PCN / EOL Notification

Product Change Notification Number: RC103801

Title: AT91SAM7S128 MRL B Revision and Ordering Code Change

Top side marking:

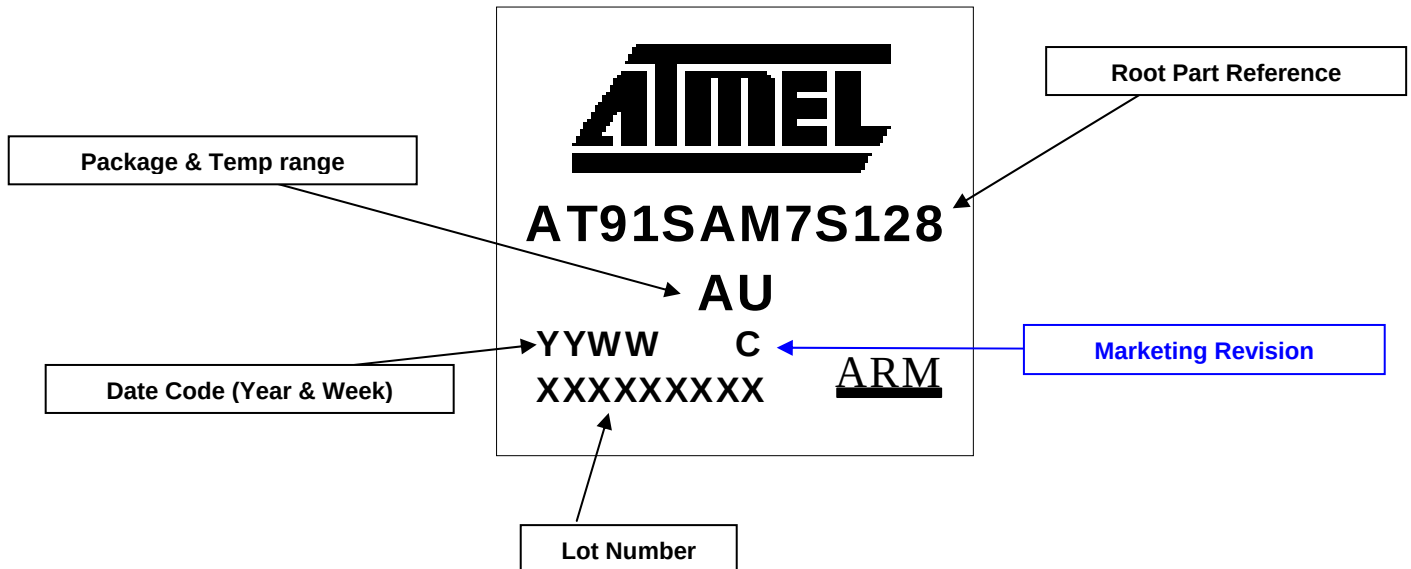
Marketing Revision on the topside marking will be incremented from B to **C**.

Chip-ID: AT91SAM7S128 Revision C chip ID is: 0x270A0742
